AMENDMENTS TO THE DRAWINGS

Attached hereto are 2 sheets of corrected drawings that comply with the provisions of 37 C.F.R. §1.84. The corrected formal drawings incorporate the following changes:

FIG.4

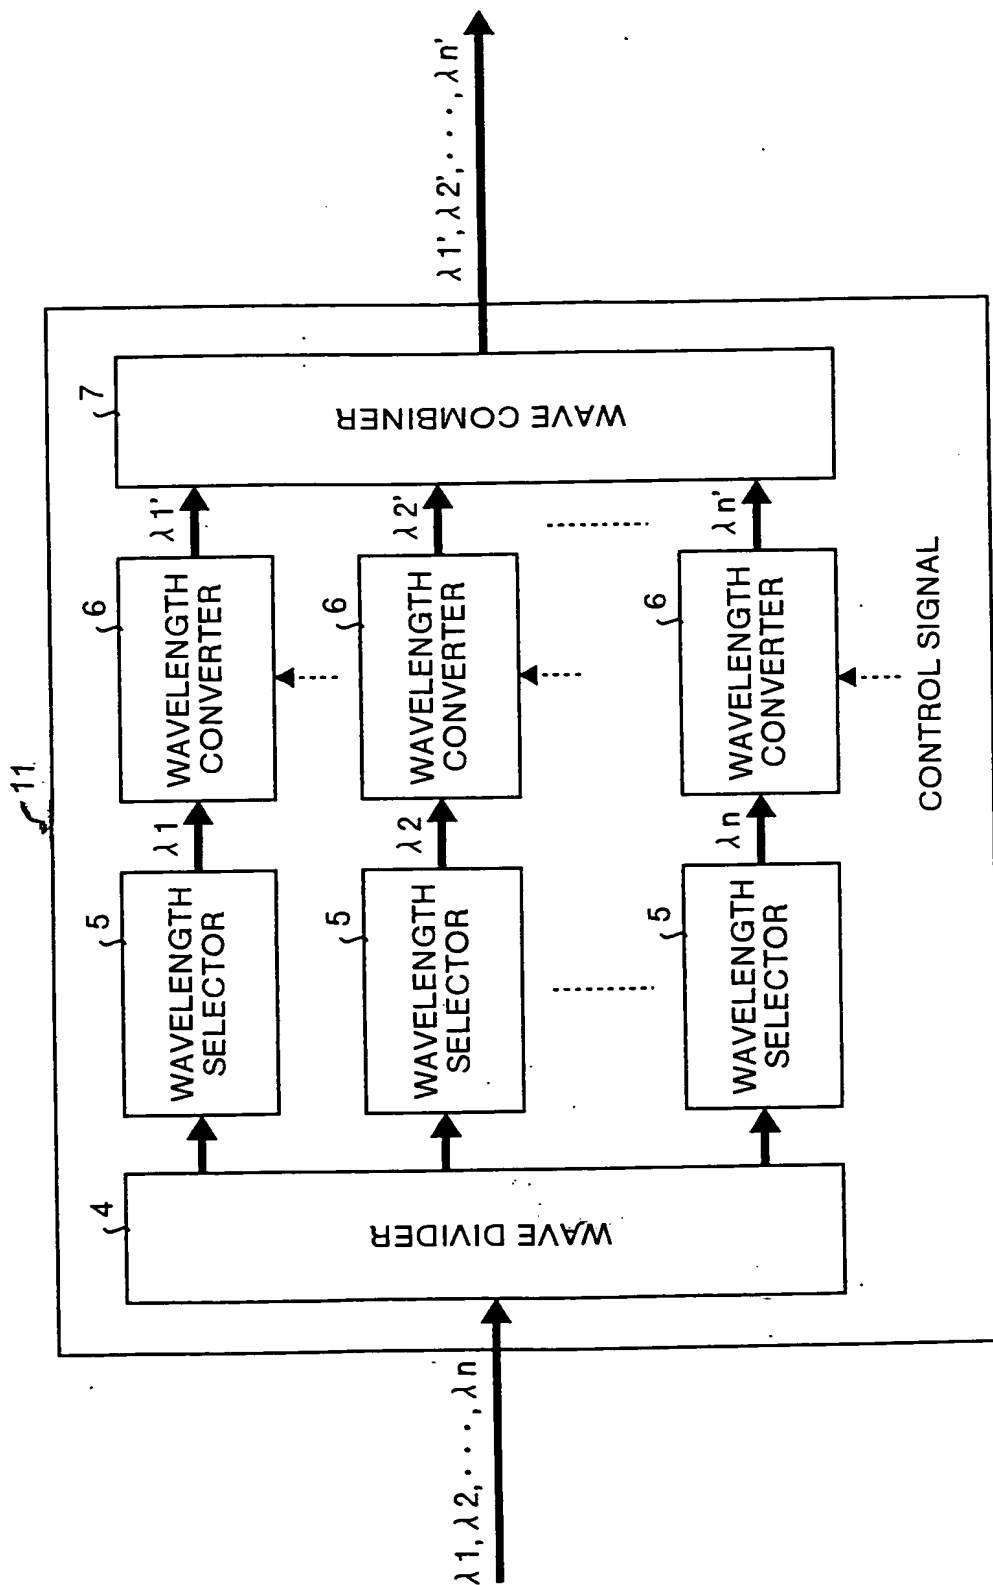
- In Figure 4, the optical repeater has been renumbered to be "11" to be consistent with the specification (see e.g. *page 4, line 16 of the specification*); and
- In Figure 9, the wavelength converting element has been renumbered from "11" to "105" to avoid repetition of element numbering - the optical repeater of Figure 4 is numbered as "11". Note that the specification has been amended accordingly to be consistent with the new number.
